TRANSMITTAL OF INFORMATION ADDRESSING KEY TECHNICAL ISSUE (KTI)
AGREEMENT ITEMS CONTAINER LIFE AND SOURCE TERM (CLST) 1.05, 1.06, 1.07, AND 2.07

AGREEMENT'S CLST 1.05, 1.06, 1.07, AND 2.07

AGREEMENTS CLST 1.05, 1.06, 1.07, AND 2.07

Figure 1. Alloy 22 Mean Corrosion Rate and Data Spread versus Exposure Time

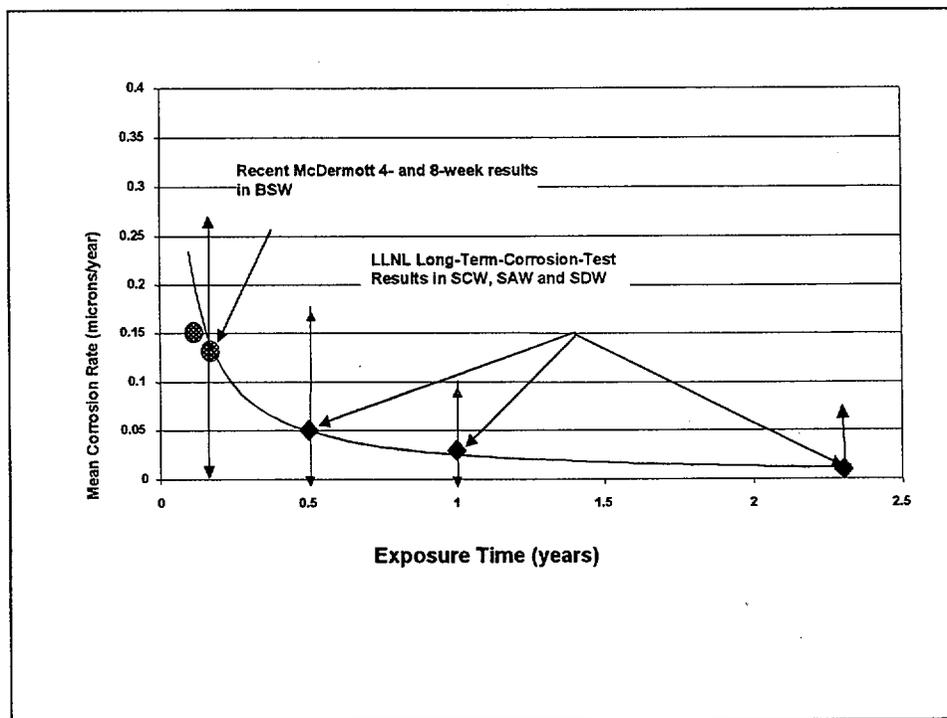
As mentioned earlier, the underlying concern of the three agreement items CLST 1.05, 1.06, and 1.07 is the measurement uncertainties associated with the Alloy 22 corrosion rates obtained by weight loss methods. The work proposed in the agreement items, namely the use of high sensitivity probes, silica free environment tests, and the use of alternative methods, was intended to provide a better understanding of the uncertainties in the measurements and improve confidence in using the measured corrosion rates. At the time this work was proposed, the determination of the corrosion rates was complicated by uncertainties in the measurements, protective effects of deposits, and incomplete descaling. These alternative methods were considered to provide a measure of true (intrinsic) corrosion rates of Alloy 22 i.e. with very low

measurement uncertainties. While the DOE agrees that it is desirable to establish the intrinsic corrosion rates, for risk-based performance assessment calculations consistent with 10 CFR 63, it is more important to establish corrosion rates in relevant environments and understand the range of uncertainties in these rates. This is particularly true for materials such as Alloy 22, which exhibits very low corrosion rates. The following proposed approach for addressing the underlying concerns is the same for all of the three agreement items. Therefore, it is appropriate that these three agreement items are treated together and apply the following discussion as the basis to consider these agreement items complete.

It is expected that the corrosion data from the 5-year exposed samples will improve the confidence in the currently available measured corrosion rates. The 5-year samples are expected to show lower corrosion rates than the 2-year samples with a smaller range of uncertainties. This expectation is based on the corrosion rate data obtained so far. Figure 1 shows the measured corrosion rates as a function of exposure times in the LTCTF at the Lawrence Livermore National Laboratory (LLNL). Also shown for corroborative purposes, are the 60 – 90 °C short-term (4-week and 8-week exposure) data obtained at the McDermott Laboratory facility (Reference 3). The data shows that after an initial sharp reduction in corrosion rate (within the first 6-months), the rates decrease with exposure time. This suggests that there is limited metal loss due to corrosion after the initial period or that the metal loss is too low to be discernible. The decrease is likely due to the fact that the passive film formed during the initial period is highly protective and essentially no further corrosion occurs in the LTCTF environments. Data from the 5-year samples are expected to follow this trend with the resulting corrosion rates lower than the 2-year sample data, which were used for the Total System Performance Assessment (TSPA)-Site Recommendation. It can also be seen in Figure 1 that the range of uncertainty/variability shows a systematic reduction as the exposure times increase.

Figure 2. Electrochemically measured rates equivalent to two-year rates measured by descaled weight loss (Preliminary data from LLNL)

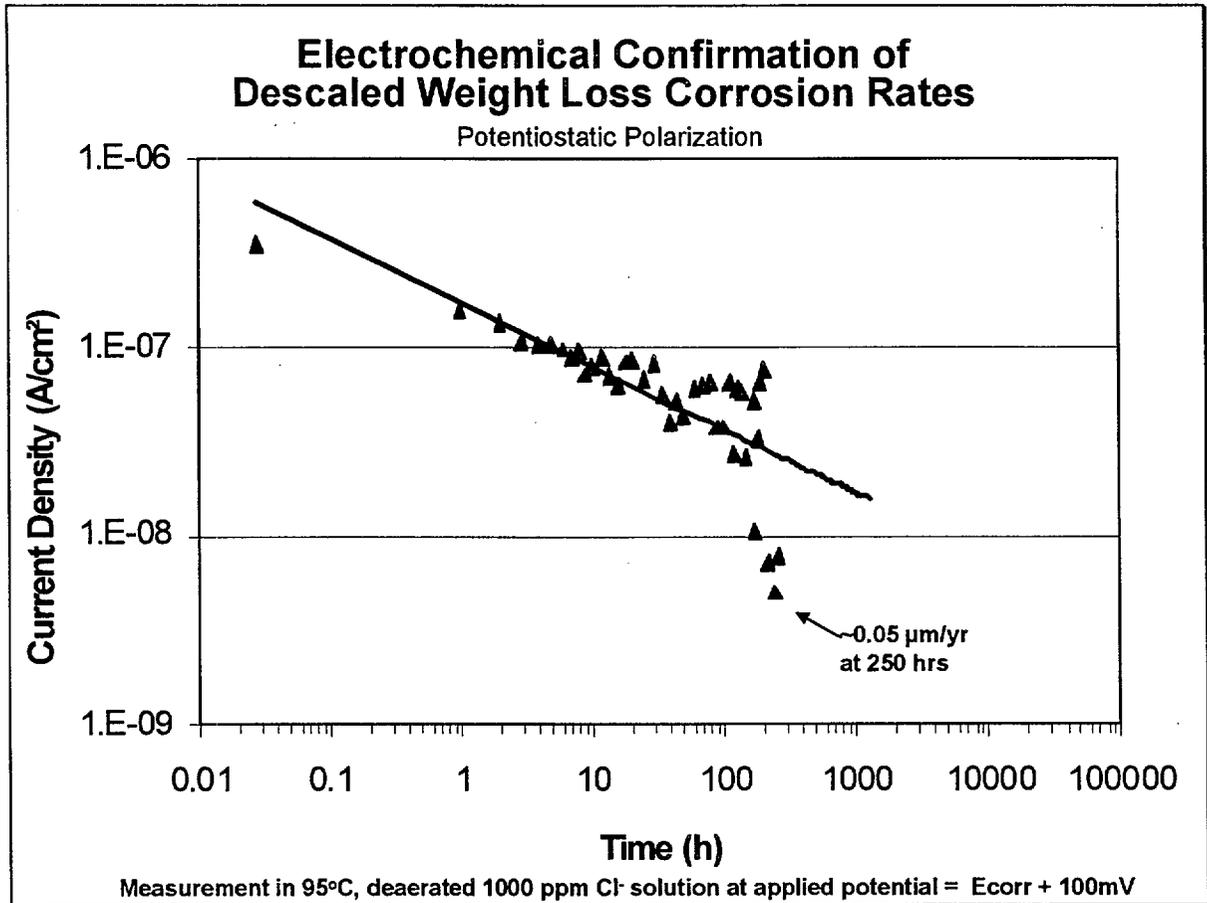
Agreement item CLST 1.06 relates to corrosion testing in the absence of silica. The weight loss data obtained previously from the LTCTF showed that some of the samples exhibited negative values for weight loss even after descaling as documented in Process Model Report TDR-WIS-MD-000002, REV 00, ICN 02 (Reference 4). The Analysis/Model Report (AMR) documented that this weight gain could be due to the presence of silica bearing deposits, which were not completely removed by the descaling operations prior to weight loss measurements. This was

To resolve this question, tests in silica free environments were proposed as a possible approach. The DOE expects that any aqueous film contacting the waste package will most likely contain silica either from the mineral precipitates or from the dust deposits on the waste package surface. Thus, the data from the LTCTF are considered representative of realistic environments in the repository. Therefore, the current DOE plans do not include provisions to conduct long-term corrosion testing in silica-free environments. While the DOE agrees that it is desirable to establish the intrinsic corrosion rates, for risk-based performance assessment calculations consistent with 10 CFR 63 it is more important to establish corrosion rates in relevant environments and understand the range of uncertainties in the measurements. This is particularly true for materials such as Alloy 22, which exhibit very low corrosion rates.

While no long-term testing in silica-free environments is planned, limited short-term potentiostatic tests in the absence of silica have been conducted. The results show that there is no discernible difference in the estimated corrosion rates (based on measured passive current densities) in comparison to the data from the LTCTF. Figure 2 shows an example of corrosion data obtained in a dilute pure chloride solution subjected to potentiostatic testing. These data show that, with an applied potential of 100 mV more positive than the corrosion potential (of about -200mV), for 250 hours in a 1000 ppm Cl⁻ solution at 95°C the corrosion rate was approximately 0.05 microns/year. The corrosion rate was calculated from the measured current densities using Faraday's Law per ASTM G 102. This is within the range of the rates obtained from the LTCTF weight loss measurements. Therefore, the postulated protective effects of silica deposits, if any, are not very significant. This will be further verified when the 5-year exposed samples are examined and characterized in detail. A detailed discussion can be found later in this Section describing how the 5-year samples will be analyzed for deposits including their effect on corrosion rates.

Agreement item CLST 1.07 requires the DOE to measure corrosion rates using alternative methods or justify the current approach of using the LTCTF data. This agreement item is also related to CLST 1.03, which calls for confirmation of linear polarization measurements with corrosion rate measurements using other techniques. The DOE is conducting corrosion rate measurements using alternative methods such as potentiostatic testing and linear polarization. However, results of this testing will be used only to corroborate the results of the LTCTF. The DOE plans to continue with the current approach of using the weight-loss data from the LTCTF including those from the 5-year exposed samples as the primary data for Alloy 22 general corrosion rates. This approach is justified in view of the fact that the corrosion rate decreases with exposure time so that data from the 5-year samples are more representative of the long-term steady state general corrosion rates than the short-term test conditions. Data shown in Figure 2 also support this view that corrosion rates from the short-term electrochemical tests can be used to validate the LTCTF weight loss data for corrosion rates.

Figure 3. Effect of temperature on repassivation potential (E_{rp}) for welded and base metal of Alloy 22 compared to corrosion potential E_{corr} (Note: Data excerpted from CNWRA presentation by N. Sridhar to NWTRB, May 9, 2001, [Reference 5]).

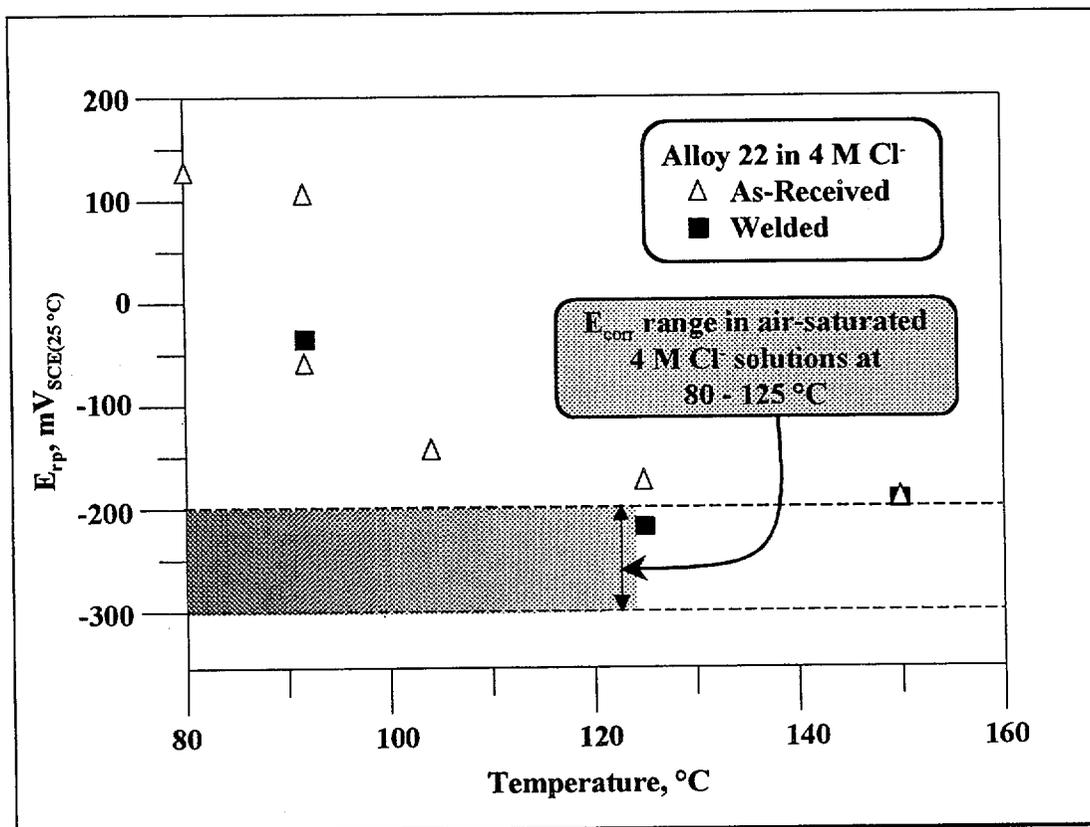
Another concern associated with temperatures higher than the LTCTF test temperatures, is the possibility of localized corrosion causing a higher effective corrosion rate than occurs with general corrosion for which LTCTF data are representative. However, corrosion potential measurements carried out by the Center for Nuclear Waste Regulatory Analysis (CNWRA) suggest that corrosion potentials do not exceed repassivation potentials even at temperatures as high as 150°C (Reference 5). Figure 3 shows the variation in repassivation potential with temperature for an environment (silica-free, chloride only without the presence of other corrosion inhibiting anions) that is more aggressive than would be expected in the Yucca Mountain repository. Based on these data, it can be concluded that the corrosion rates measured in the LTCTF can be extrapolated to higher temperatures with reasonable confidence that localized corrosion will not occur.
